Access Compliance Report

Public Rights-of-Way

Intersection ID: 52573	Main Street: NEW RENAISSANCE_WY	Cross Street: NOBLES_AV	Location: SE
ADA ID: 43740483B29B	Ramp Type: Perp	Initial Pass/Fail: Fail	Overall Compliance: No
Severity Score: 12.5			
Codes/Mitigation Info/Possible Solution		Field Measurements/Component Compliance

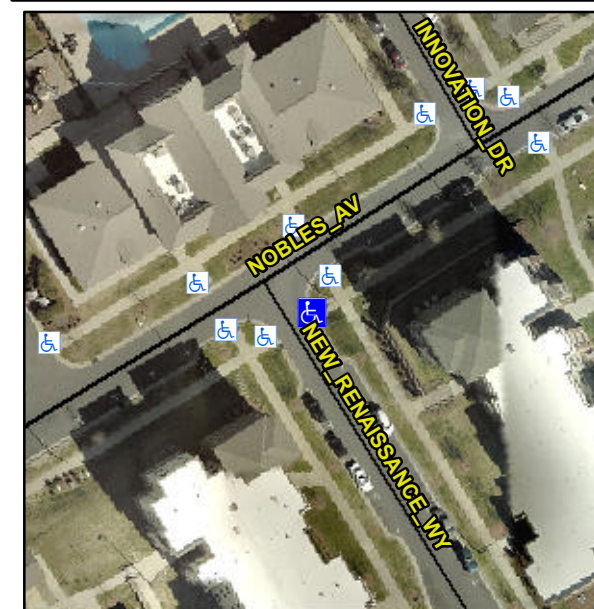
R304.2.2

Compliance	Description	Data	Compliance	Description	Data
N/A	Ramp Length (in)	72.0	No	Ramp Slope (%)	9.1
Yes	Ramp Width (in)	70.0	Yes	Ramp XSlope (%)	0.7
N/A	Flare Type LT	N/A	N/A	Flare Type RT	N/A
N/A	Flare Slope LT (%)	N/A	N/A	Flare Slope RT (%)	N/A
N/A	Flare Traversable LT?	N/A	N/A	Flare Traversable RT?	N/A
N/A	Landing Length (in)	N/A	N/A	DWS Provided?	N/A
N/A	Landing Width (in)	N/A	N/A	DWS Contrast?	N/A
N/A	Landing Slope (%)	N/A	N/A	DWS Length (in)	N/A
N/A	Landing X Slope (%)	N/A	N/A	DWS Full Width?	N/A
N/A	Landing Curb? (Y/N)	N/A	N/A	DWS Offset (in)	N/A
N/A	Shared Landing?	N/A			
N/A	Gutter Ponding?	N/A	N/A	Gutter Slope (%)	N/A
N/A	Gutter Lip Ht (in)	N/A	N/A	Gutter X Slope (%)	N/A
N/A	Painted X Walk1?	No	N/A	Painted X Walk2?	N/A
	X Walk 1 Direction	To SW		X Walk 2 Direction	N/A
N/A	X Walk 1 Width (in)	N/A	N/A	X Walk 2 Width (in)	N/A
	X Walk 1 Slope (%)	2.8		X Walk 2 Slope (%)	N/A
	X Walk 1 X Slope (%)	2.1		X Walk 2 X Slope (%)	N/A

Remove & Replace Entire Ramp.

Total Cost: \$ 1850.00
